Reply on Referee #1 Stefan Wacker (AMT-2022-259)

Reply on Referee #2 (AMT-2022-259)

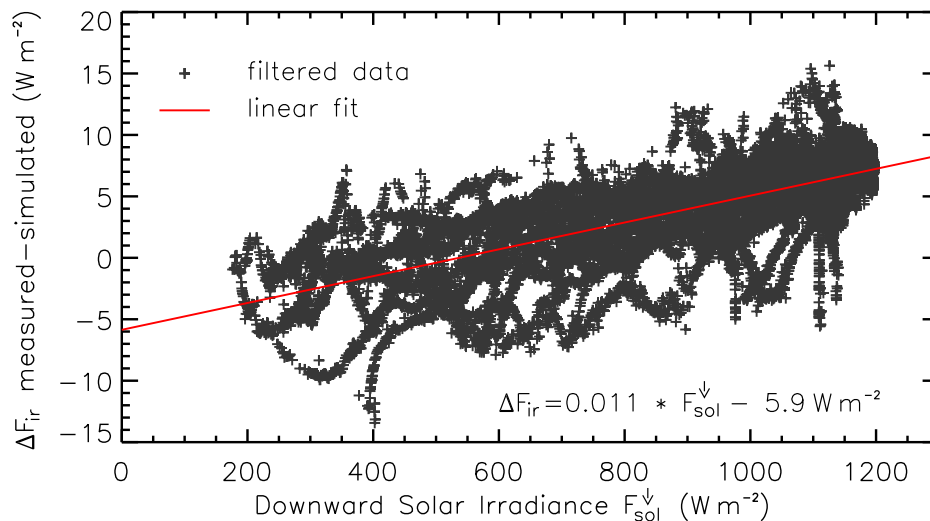
Corrections methods and their evaluation are thoroughly described for the shortwave and longwave. In addition, a comparison of the observations with radiative transfer calculations for the downwelling and upwelling shortwave radiative fluxes for horizontal, circular flight patterns has been presented. Such a comparison would be also highly valuable for the (downwelling) longwave in order to estimate the reliability of the longwave observations and to study potential effects which may become relevant in the longwave on such flights. For instance, the fraction of the direct solar beam above the cut-on of a pyrgeometer, which is at about $4.5 \mu\text{m}$ for a CGR4. This unintentionally observed portion of the direct solar beam depends on the water vapor content (and thus altitude) and the solar zenith angle and hence may exceed 5 W m^{-2} significantly on such flights (e.g., Marty, 2000). In addition, the dependency of the pyrgeometer sensitivity on the water vapor content, which is estimated to be about 5 W m^{-2} in cloudfree conditions, may also be considered in such applications (e.g., Nyeki et al., 2017).

Thanks for this valuable suggestion! We did not simulated the thermal-infrared downward irradiance due to the higher sensitivity to the water vapor column above the aircraft and the distance to the radiosondes. That's why we did not expect to be able to

identify this bias. We now run the simulations of downward thermal-infrared irradiance for the EUREC4A measurements with the best estimate of the atmosphere profile and compared to the measurements. Indeed, a slight positive bias of up to 10 W m^{-2} is observed when the downward solar radiation is high. In the revised manuscript, we included this analysis and discussed the offset.

The HALO flights of EUREC⁴A have mostly been performed at flight altitudes above 10 km and under often cloud-free conditions above HALO, causing high values of downward solar irradiance. In such conditions the solar leakage of the pyrgeometer dome interference filter can produce an overestimation of the thermal-infrared irradiance (Philipona et al., 1995; Marty, 2000; Meloni et al., 2012). For cloud-free ground-based measurements, Meloni et al. (2012) identified an overestimation of up to 10 W m^{-2} depending on the amount of downward solar irradiance.

This bias was investigated for BACARDI using radiative transfer simulations of $F_{\text{ir}}^{\downarrow}$ which are reliable and can serve as a benchmark for measurement above 10 km and under cloud-free conditions. The simulations have been performed along the HALO track, considering the time of day, the geographical position, and flight altitude of HALO with a temporal resolution of at least 30 s. The radiative transfer solver DISORT 2.0 and the lowtran parameterization of molecular absorption embedded in libRadtran are applied (Emde et al., 2016; Stamnes et al., 2000; Ricchiazzi and Gautier, 1998). In the simulations, the cloud-free atmosphere is defined by merged temperature and humidity profiles from the Barbados Cloud Observatory radiosondes (BCO, Stevens et al., 2016; Stephan et al., 2021), and the frequent dropsonde measurements from HALO (George, 2021).

Filtered for cloud-free condition, Figure 9 shows the difference between measured and simulated $F_{\text{ir}}^{\downarrow}$ as function of the measured downward solar irradiance $F_{\text{sol}}^{\downarrow}$. The data indicates a trend to overestimate $F_{\text{ir}}^{\downarrow}$ for increasing $F_{\text{sol}}^{\downarrow}$. For values of $F_{\text{sol}}^{\downarrow}$ above 1000 W m^{-2} , typical for times around solar noon, the bias ranges up to 10 W m^{-2} comparable to the findings of Meloni et al. (2012). A linear regression suggest an increase of the bias by 1 W m^{-2} for each 100 W m^{-2} increase of $F_{\text{sol}}^{\downarrow}$. However, the data shows a large variability and the regression suggests a negative bias for the absence of solar radiation. This may be attributed to remaining uncertainties of the radiative transfer simulations and the pyrgeometer sensitivity due to changes of water vapor concentrations above HALO (Nyeki et al., 2017), a permanent biases of the radiometer calibration, and a static thermal offsets
